Midcoast Community Council

Response to Cypress Point Draft EIR

Project Title: Cypress Point Affordable Housing Community Project
(SCH# 2022120189)

9/21/23

Figure 6 - Geologic Hazards on Project site

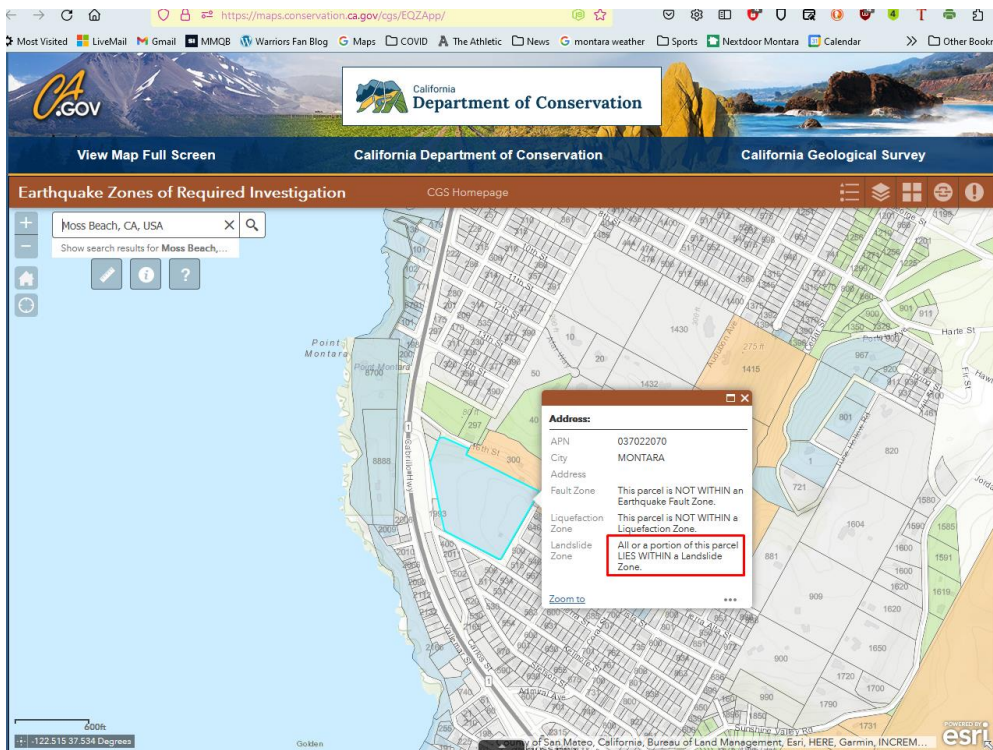
INCOMPLETE: Pg 11: *The Project site is not located within a zone of liquefaction potential on the map titled Earthquake Zones of Required Investigation, Montara Mountain Quadrangle, dated April 4, 2019, and shown on Figure 4.*

^^ Per review with UCS geologist this comment is true but a little misleading - see screenshot below. The property IS in a landslide zone at the northern boundary of the parcel. While that is different from a liquefaction zone, the landslide risk is likely more prevalent given stormwater conditions on the Midcoast.

Figure 7 - Earthquake faults near the Project

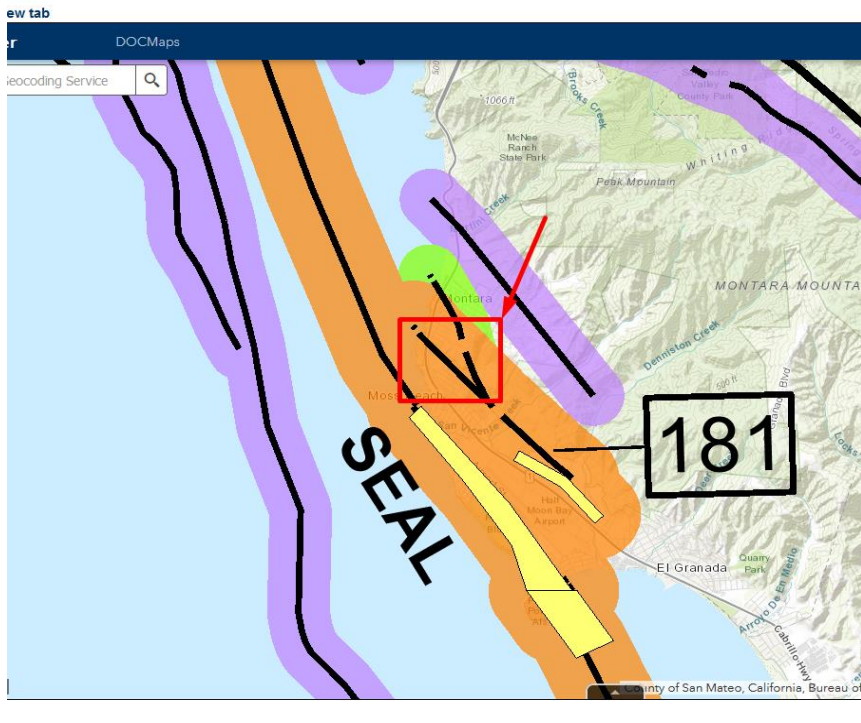
- A. Maps.conservacion.ca.gov published September 23, 2021 shows potential fault/earthquake risk – map not published in the EIR. The black fault line runs right through the Project site.

Figure 8 - Faults and Liquefaction near the Project

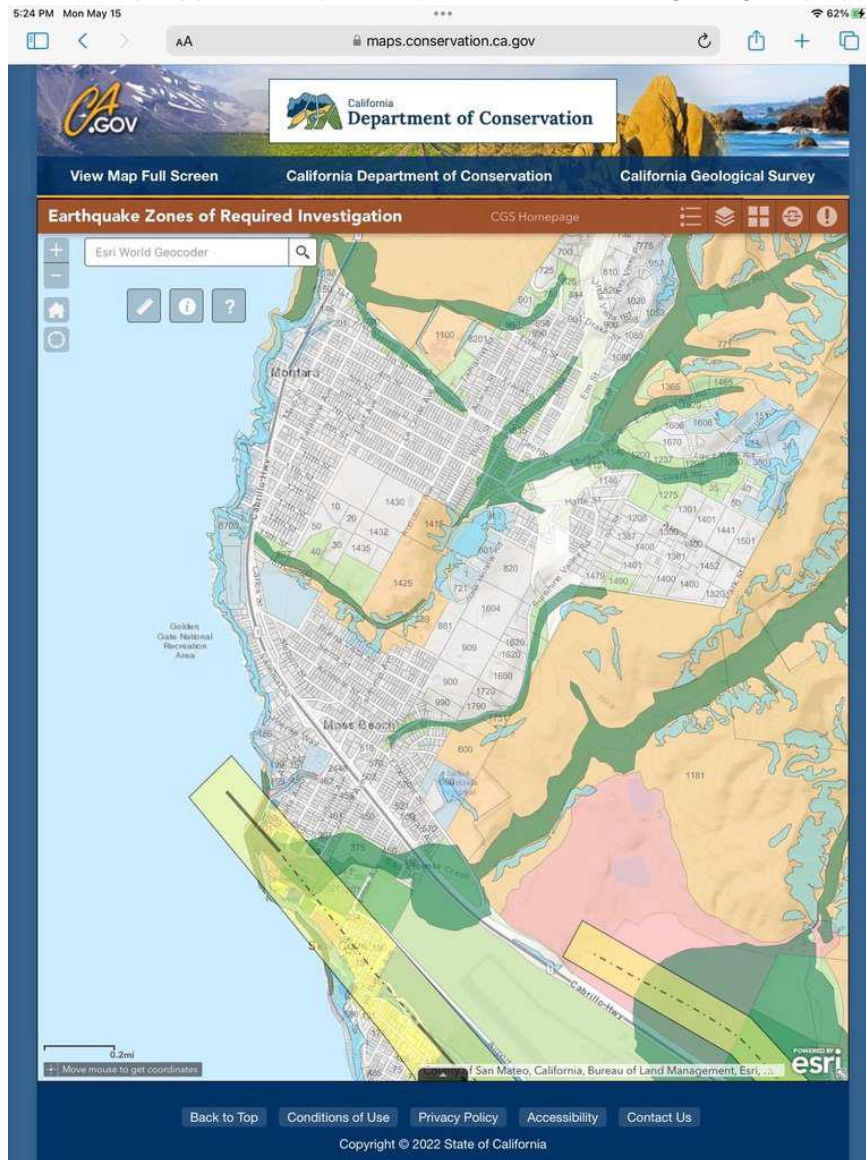
There are several earthquake liquefaction zones nearby, which could impact access to/from the site:

Per CGS geologist, the two faults in the area were removed from active status in the late 80's but are now being re-evaluated. It is clear that the site borders current Liquefaction Zones. However the State IS RE-REVIEWING this area for fault potential and re-evaluating the San Gregorio fault zone, but the study will take about another year to complete.

Figure 11 - Proximity of Fire Hazard Zones

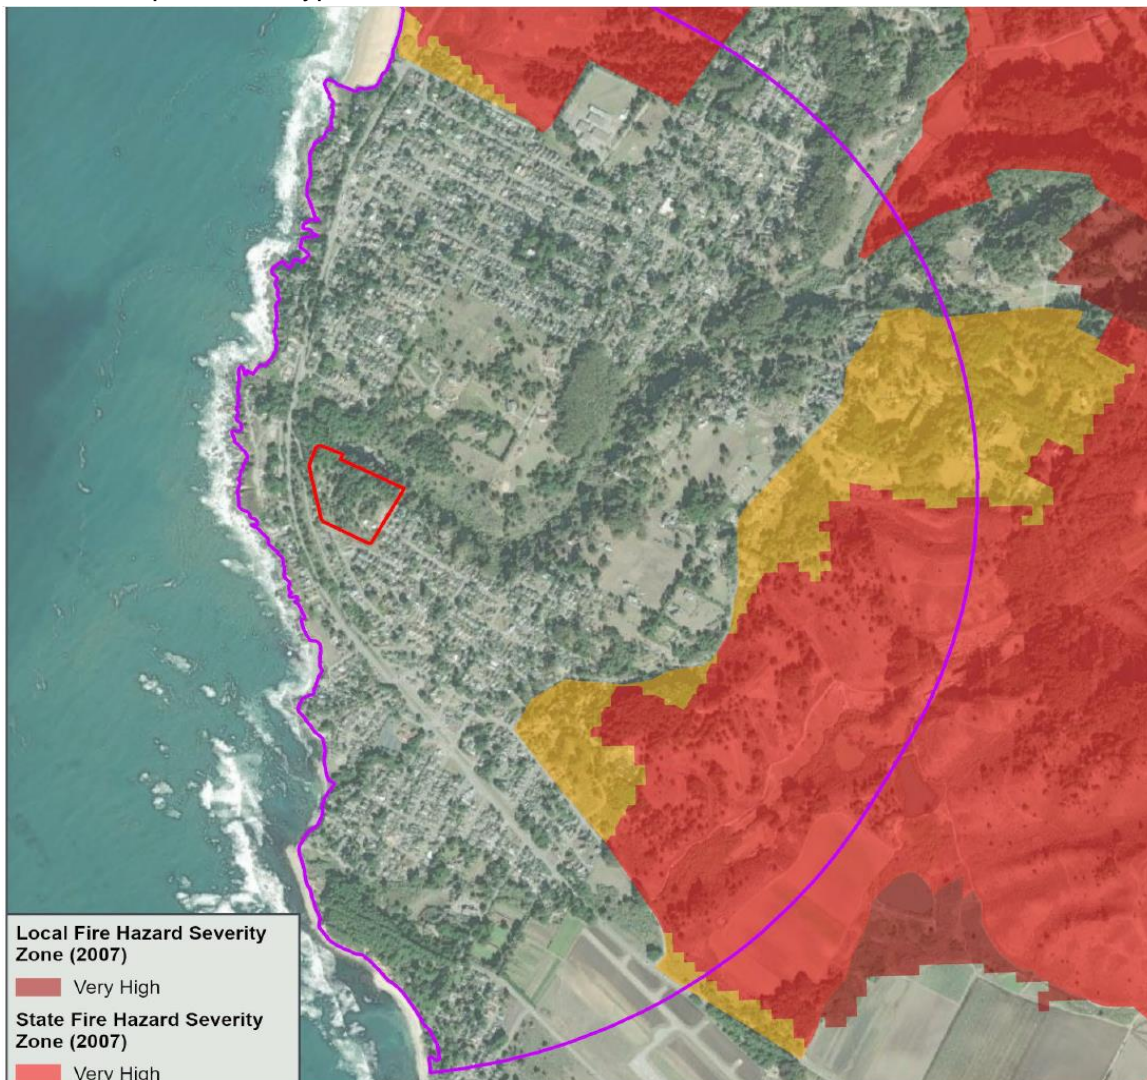
3.6 - Question #28: The list (page 230 of the pdf) states: "Would the Project expose people or structures, either directly or indirectly, to a significant risk of loss, injury or death involving wildland fires?" Since there is no evacuation plan, access to the only road out is through a chokepoint, and the area carries non-trivial wildfire risk, the answer to that question is "Yes", which means "the Project would be considered to have a significant effect on hazards and hazardous materials". Why has the Project not received this designation?

Here is the picture of Cypress Pt. contained in the DEIR:

Figure 13 - Moss Beach Drainage Pattern

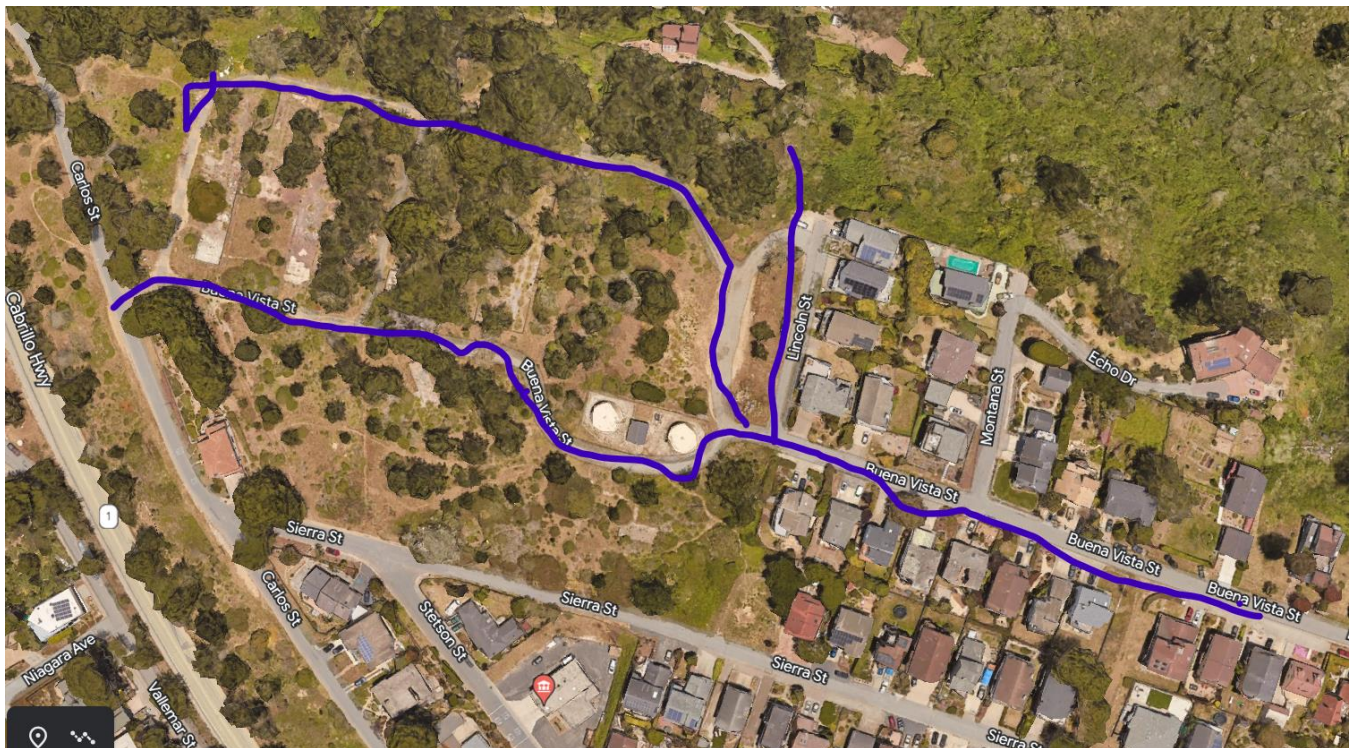
Currently, according to local residents who provide the following information, the Project site serves as an "ad hoc stormwater retention basin", which reaches 2 feet of depth near the MWSD water tanks during storms. A longtime resident's description of the drainage is as follows:

*Blue lines illustrate water run off directions. Downhill slope is **right to left** through Cypress Point Project. Primary final drainage exit is at the Carlos exit. There is severe road erosion all along the road that runs in front of the water towers due to volume of water run-off every winter. The upper hill run-off joins the Carlos and upper streets draining on to Highway 1. Result is often seen as water rushing out of the Carlos St exit and soil/rock deposits on the road. Additional drainage from Buena Vista goes down Lincoln St toward the creek or open area. Result is a large water pool in the open area that flows down the side road; or into the creek. Additional pooling occurs right of the two water towers. All runoff drains into the ocean. "*

Almost all runoff from the property flows into Montara Creek and subsequently into the Fitzgerald Marine Reserve. It only seems prudent that a large earth-moving project like this should require a robust plan to control stormwater runoff and provide reasonable assurance that development will not make the situation worse.

Figure 20 - Geologic Hazards on Project Site

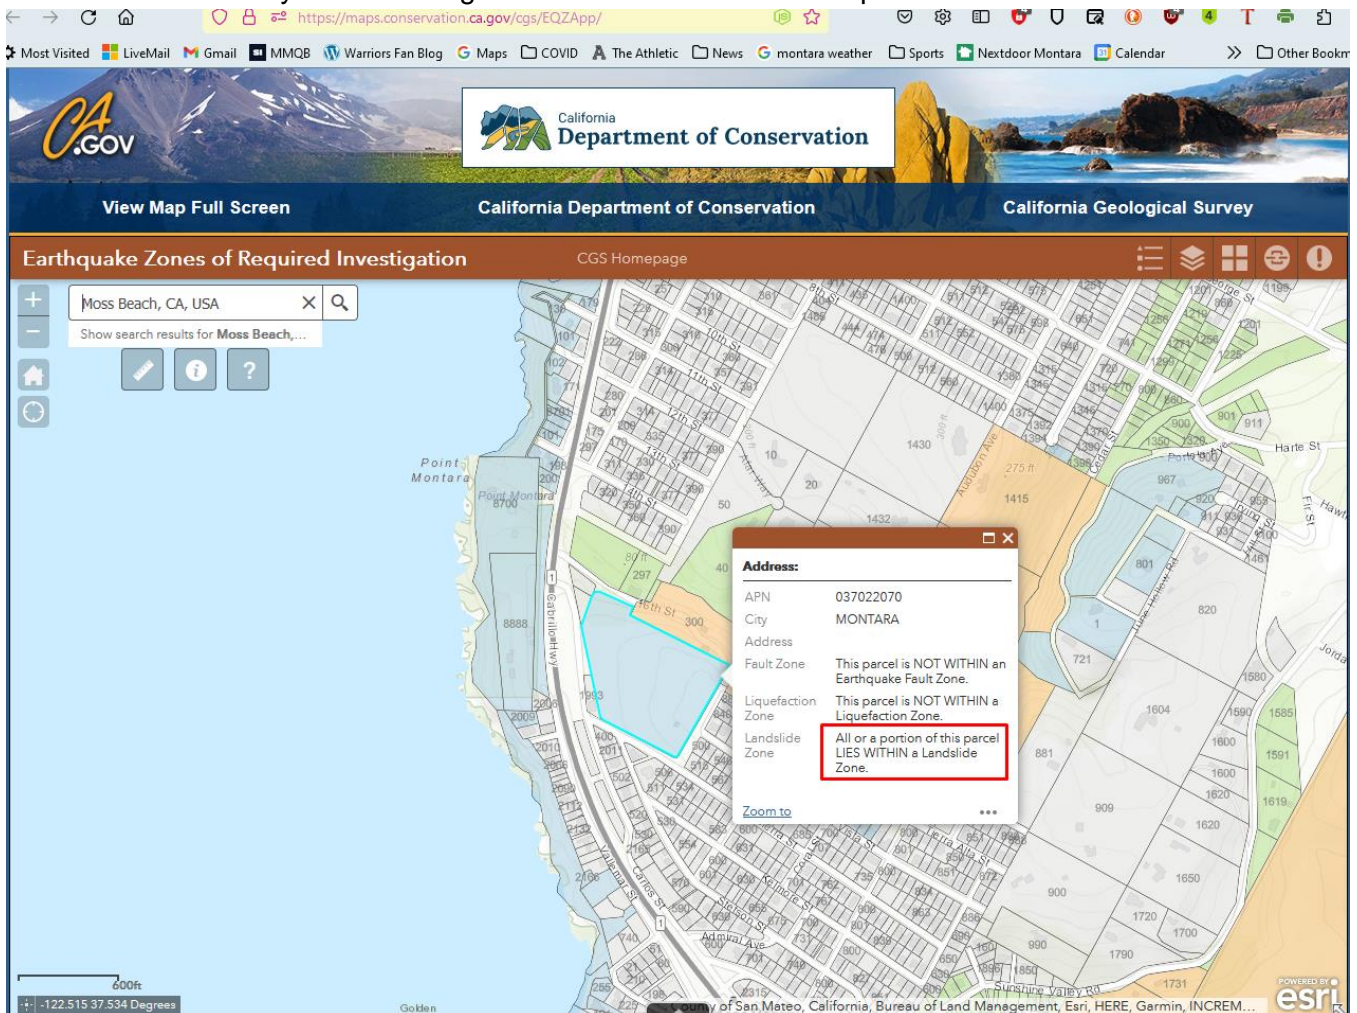
INACCURATE: Impact HYD-4: “The geology of the site is not susceptible to landslides or mudflow.”

The site shows clearly as containing landslide risk on a UCGS map:

Figure 29 - Excessive Turns and Distance for Fire Response

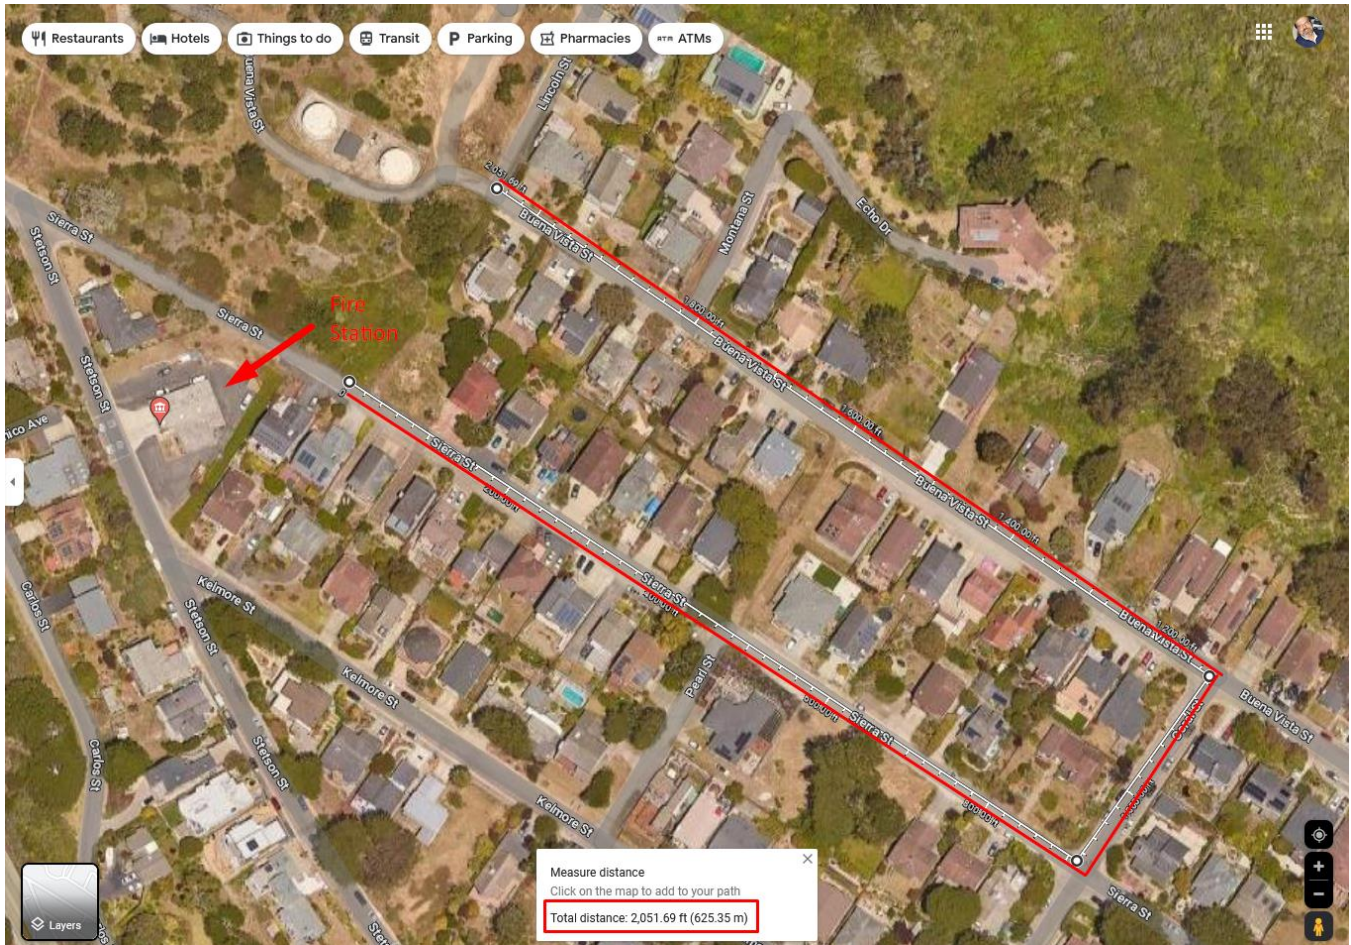
connected directly to Sierra near Stetson.

Figure 30 - Alternative Fire Truck Entrances

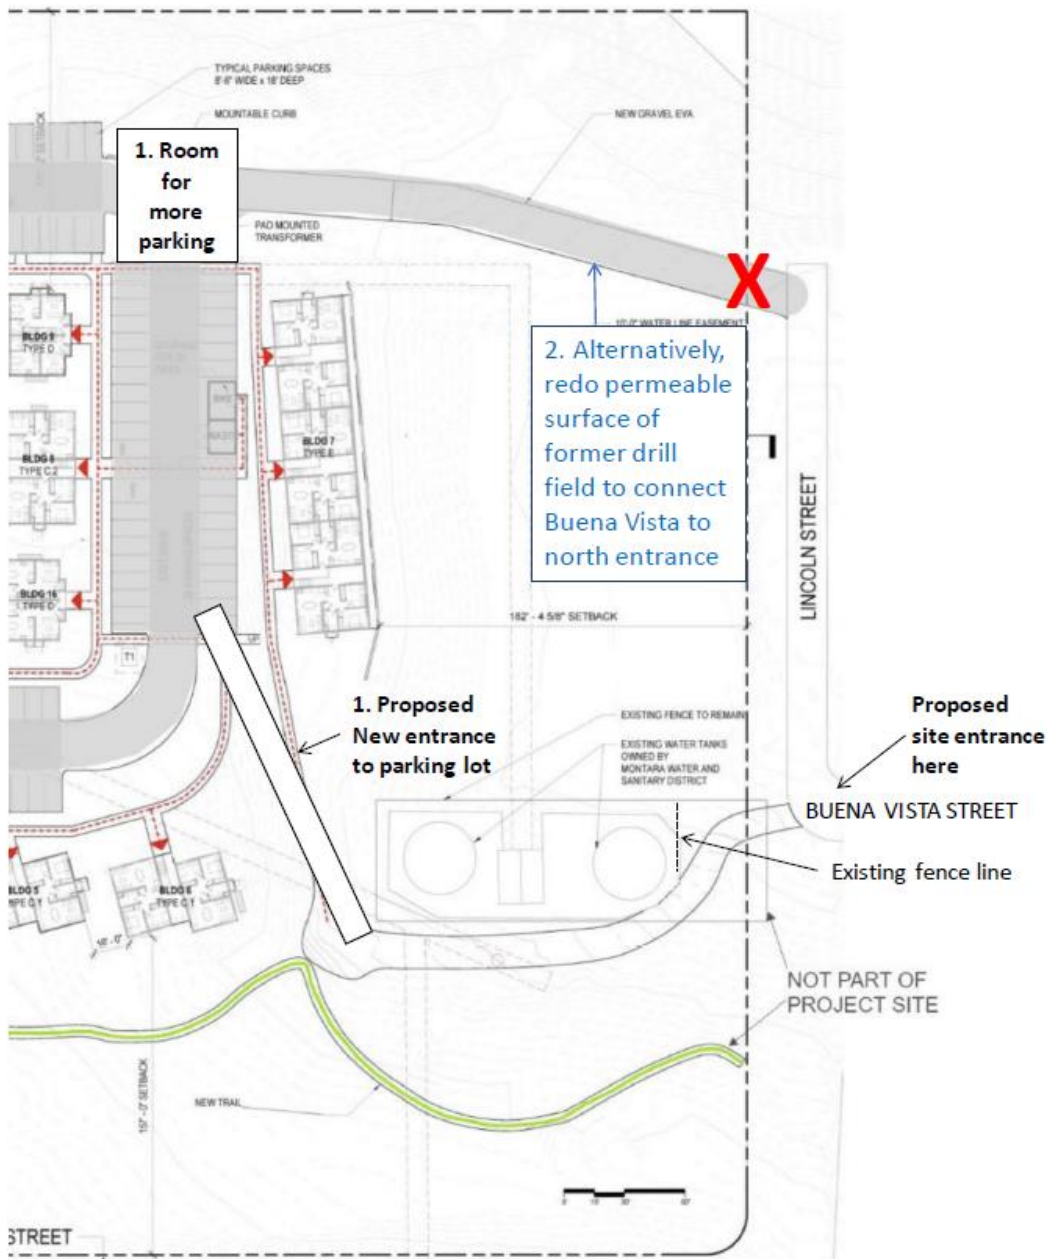
Note that fire trucks already have difficulty navigating the roads in Moss Beach (photo below) and that Carlos in only 13' wide. With implementation of the County's Complete Streets standards, adding a sidewalk and bike lane, Carlos will be even narrower and will be forced to be a 1-way street. Note also that Carlos St. has a 8° grade and California St has 15-17° grades, which already cause delivery trucks
